CHANDIGARH HOUSING BOARD

DRAWN BY Sonu-1 | 204 JOB NO. | 36 DRG.NO.

TYPICAL FLOOR PLAN
TWO BED ROOM CATEGORY FLATS
SECTOR 63
CHANDIGARH (U.T.)

TYPICAL FLOOR PLAN

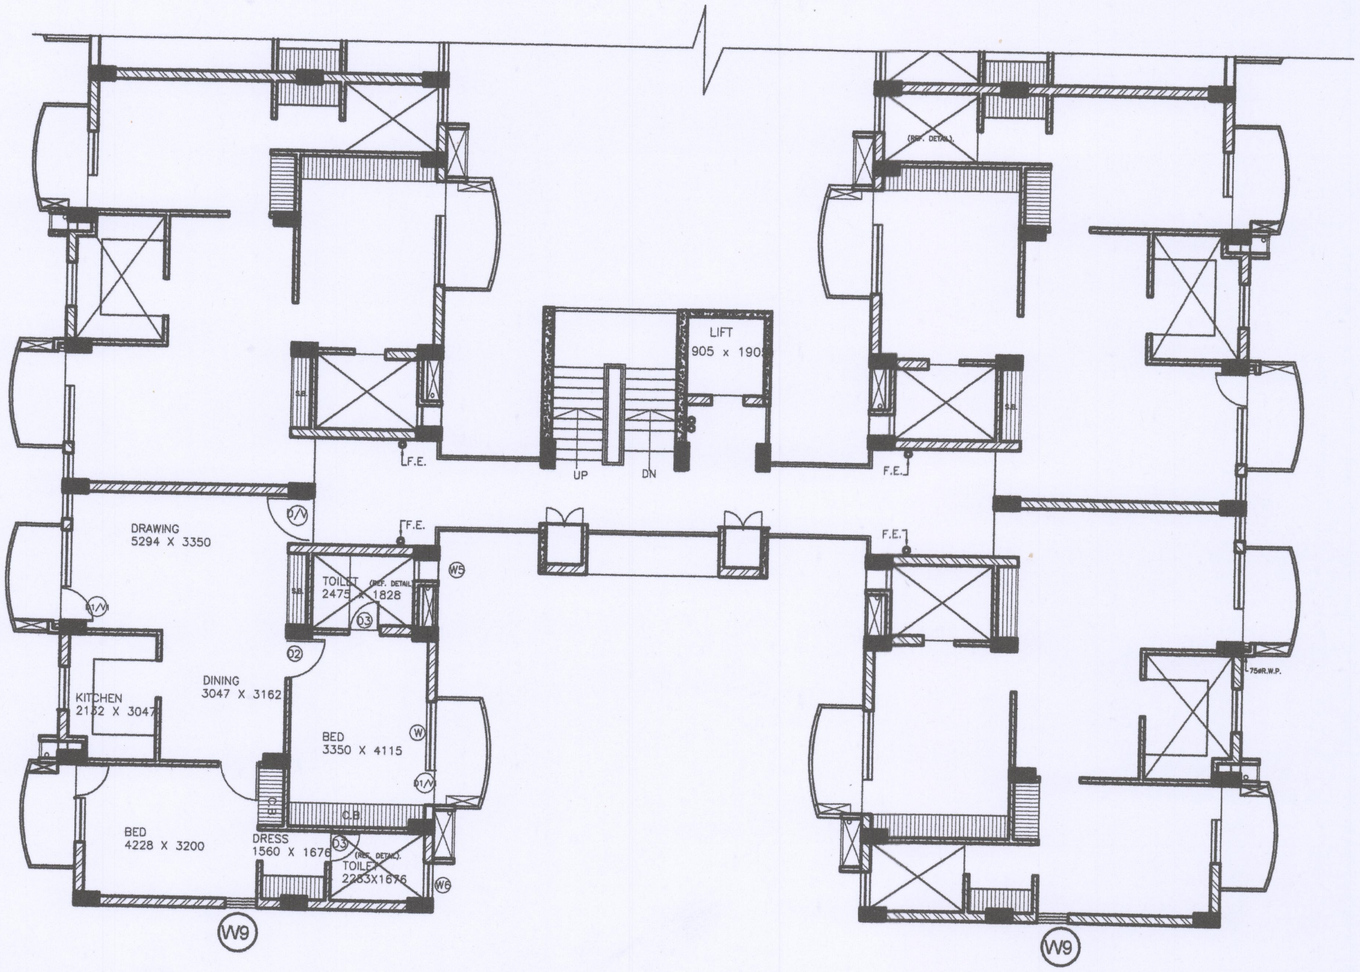
1.THE PROPOSAL OF ADDITIONAL WINDOW OF 760 MM.(2'-6")WIDTH HAVING CILL LVL. 685 MM. (2'-3"),IN END WALL WITH LINTEL LVL SAME AS OTHER WINDOWS OF D.U. ALLOWED UNDER CLAUSE A7 OF NEED BASED CHANGES 7-7-2015 IS MARKED ON THE DRGS. BASED ON APPROVED DRG. NO. 15 ,JOB NO. 204.

3.IF REQUIRED BY THE ALLOTTEE TO ADD ANY ADDITIONAL WINDOW IN THE END WALL OF D.U. AS PER CLAUSE A7 THEN IT SHOULD BE ADDED AT THE LOCATION SHWON AT W9

4.THE LOCATION, SIZE,CILL LVL. & LINTEL LVL. OF WINDOW SHOWN IN END WALL OF CORNER UNIT IS APPLICABLE OF ALL D.U. I.E. G.F.AND UPPER FLOORS SO THAT THE WINDOWS OF ALL FLOORS ARE VISIBLE IN SAME LINE IN ELEVATION.
